County of Fairfax, Virginia

Re: Interpretation for PCA 79-C-089 and SEA 00-Y-017, Dulles Business Park Asha Hotel, Tax Map Parcel 34-4 ((12)) C-3: Hotel A Footprint and Elevations

Re: Asha Hotels (formerly Axar Management, Inc.)
Dulles Business Park - Tax Map No. 34-4-((12)-C3
SEA 00-Y-017 and PCA 79-C-089
Substantial Conformance Request

Re: Asha Hotels (formerly Axar Management, Inc.)
Dulles Business Park - Tax Map No. 34-4-((12)-C3
SEA 00-Y-017 and PCA 79-C-089
Substantial Conformance Request

East Elevation scale: 1"=20'

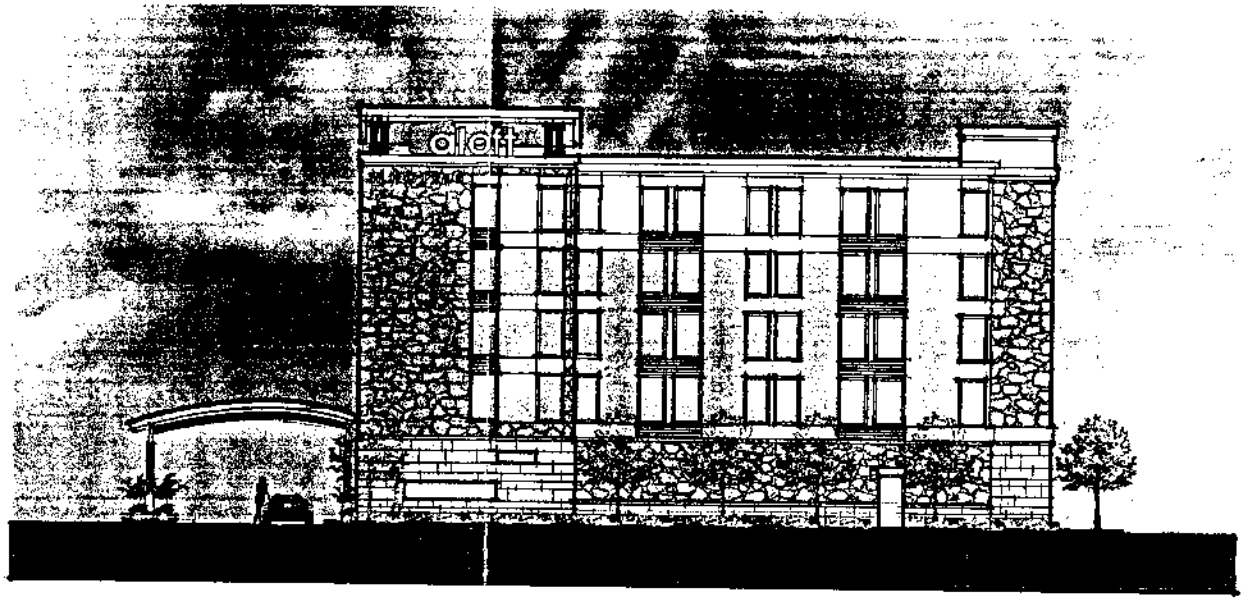
As you know, this firm represents Asha Hotels (formerly Axar Management, Inc.), owner and developer of the above-referenced property. In our recent telephone conversation, you advised that the architectural rendering for the proposed Westin Aloft Hotel submitted to your office on June 15, 2006, would not be in substantial conformance with prior approvals. Based upon that conversation, I am submitting a revised design for your review.

As noted in the proffers, the original elevations were illustrative, and the future design and architecture of the hotel should be in substantial conformance with the "general design" depicted on the elevations. In response to your comments and in accordance with the proffers, the enclosed elevation now more closely mirrors the previously approved elevation. It incorporates similar types and proportion of building materials, including use of stone and shape of windows, and the revised design retains the porte-cochere and landscaping at the building's foundation. Further, the proposed building materials and design will be high-quality and blend in with the Dulles Business Park.

Again, we request your determination that the revised architecture is in

substantial conformance with the SEA/PCA approvals. Your time and assistance is greatly appreciated

The elevations for both Hotel A and Hotel B show traditional Colonial architecture with pitched roofs, gables, and primarily masonry construction. Hotel B has been built as a Staybridge Suites Hotel with architecture which conforms to the elevation for Hotel B. You have submitted two separate proposed elevations for Hotel A on June 15, 2006, and on July 18, 2006, respectively. Both of the proposed elevations depict a modernistic design with a flat roof. The first elevation submitted showed very modern rainbow striped features extending above the flat roofline and over the main entrance. You were verbally advised by staff that this elevation was not in substantial conformance with the required elevation. The elevation submitted with your letter of July 18, 2006, continues to be a flat-roofed structure which no longer contains the modernistic features on the roof, or over the entrance. However, it does not incorporate the traditional features of the required elevation, such as the pitched roof, gables, and arched portico at the entrance. The basic style of both of the proposed hotel prototypes appear to use a theme or style which was not incorporated into the approved PCA and SEA.

As such, it is my determination that the proposed elevations for Hotel A that were submitted on June 15, 2006, and July 18, 2006, are not in substantial conformance with the PCA proffers and SEA development conditions.

Westin Aloft Hotel - Standard Prototype

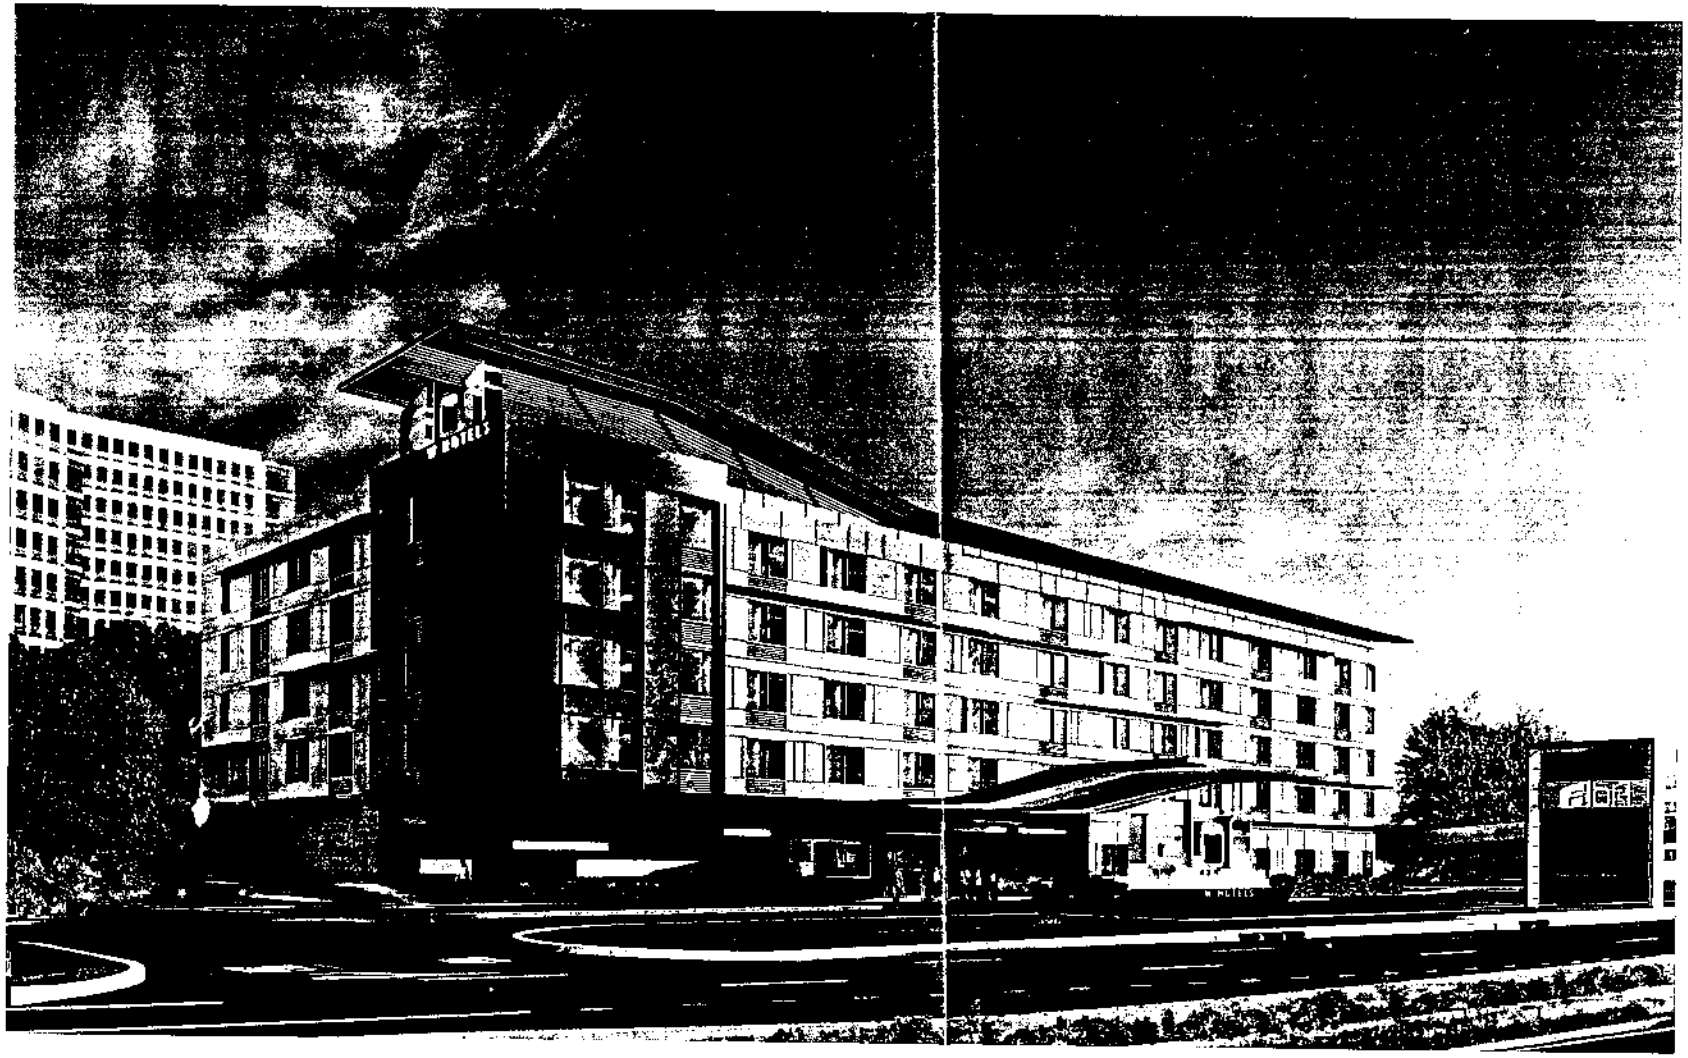
Also enclosed is a revised architectural rendering of the proposed Westin Aloft Hotel. Development Condition #6 and Proffer #5 require that the architecture of Hotel A be in substantial conformance with the illustrative elevation entitled "Hawthorn Suites Hotel" dated May 20, 2002, or be of "comparable quality" as determined by the Department of Public Works and Environmental Services. We request your determination that the revised architecture is in substantial conformance with the SEA/PCA approvals. The proposed architecture displays an aeronautical design that is fitting for its close proximity to Dulles Airport. Further, the proposed building materials and design will be high-quality and aesthetically pleasing to balance the variety of architectural designs in the Dulles Business Park.

Overall Site Plan

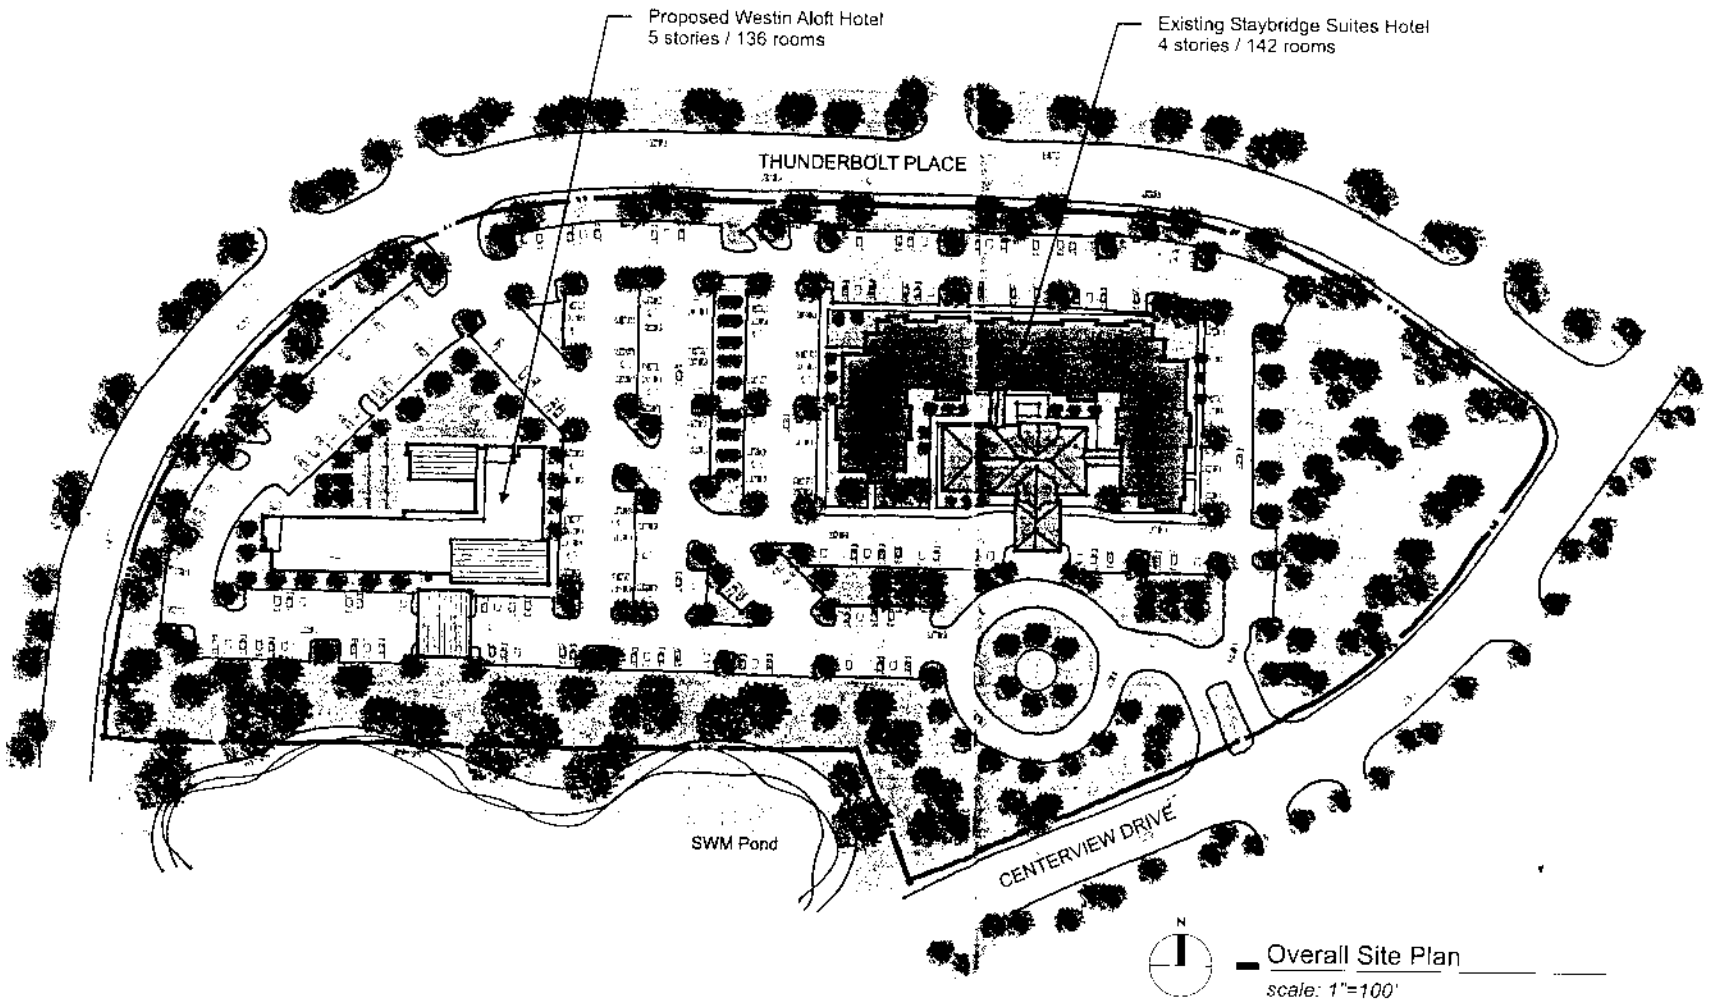
As shown on the attached drawings, Hotel A is proposed to be developed as a five story hotel with 136 rooms. Although the building footprint has been modified, it remains in the area originally shown on the special exception approvals. Further, the modified footprint breaks up the building's massing and is now oriented away from Thunderbolt Place.

As stated in your letter, the proposed modifications to the building footprint are within the area generally shown for the hotel on the GDP/ SEA Plat. The proposed design for the hotel shows a re-orientation of the building from a rectangular configuration to an L-shape. The entrance is now oriented more toward the SWM pond. Site access has not changed. The re-orientation of the footprint has removed an area of landscaped open space that was previously around the hotel entrance. It is not clear from the proposed layout if the amount of landscaped open space or number of parking spaces is impacted by the proposed change in footprint. Absent more detailed information, I am not able to determine that the modified building footprint is in substantial conformance with PCA 79-C-089 and SEA 00-Y-017.
